UNITED STATES PATENT AND TRADEMARK OFFICE

APPLICATION NO.	FILING DATE	FIRST NAMED INVENTOR	ATTORNEY DOCKET NO.	CONFIRMATION NO.
10/612,236	07/01/2003	Gary L. Brundage	pH-003	4966
27946	7590	05/05/2004	EXAMINER	
ARTHUR J. BEHIEL 6601 KOLL CENTER PARKWAY SUITE 245 PLEASANTON, CA 94566			NGUYEN, PHUONGCHI T	
			ART UNIT	PAPER NUMBER
			2833

Office Action Summary

DETAILED ACTION

Attachment 1

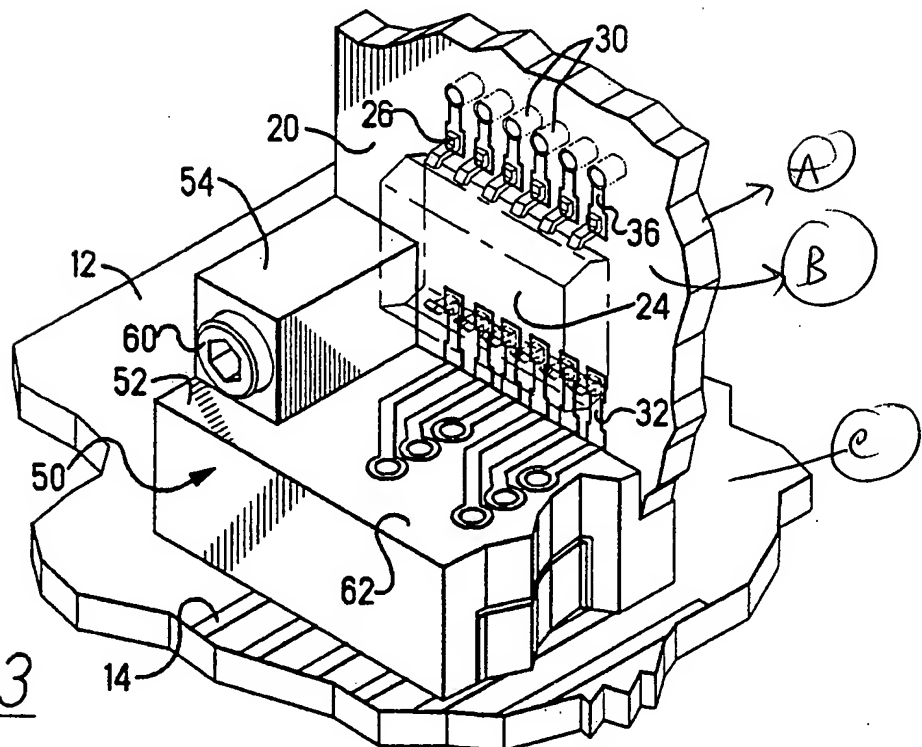
In regarding to claim 1, Zarreli discloses a connector system (Attachment 1 and 2 of figure 3 and 7) comprising a first wiring board (20) having first wiring-board surface (A) supporting a first plurality of conductors (30); and second wiring-board surface (B) extending in a first plane (of 20) and supporting a second plurality of conductors (36); wherein at least one of the first plurality of conductors (30) is electrically connected to a corresponding one of the second plurality of conductors (36); second wiring board (12) having a third wiring-board surface (C) extending in a second plane (of 12) substantially perpendicular to the first plane (of 20) and supporting a third plurality of conductors (14); an elastomeric conductor (106) (column 6, lines 38-39) disposed between the first and second wiring boards (20, 12) in contact with ones of the second (36) and third (14) pluralities of conductors; and a support (50) connected to the first and second wiring boards (20, 12) and holding the elastomeric conductor (106) against the second (B) and third wiring-board surfaces (C).

In regarding to claim 6, Zarreli discloses the connector system further comprising a housing (computer housing) encompassing the first and a second wiring boards (20 and 12).

In regarding to claim 8, Zarreli discloses the connector system further comprising a second conductor (36) contacting the housing (indirectly) and at least one of the third plurality of conductors (14) (electrically).

In regarding to claim 10, Zarreli discloses the connector system wherein the support (50) holds the second conductor (36) against the housing (computer housing) (indirectly).
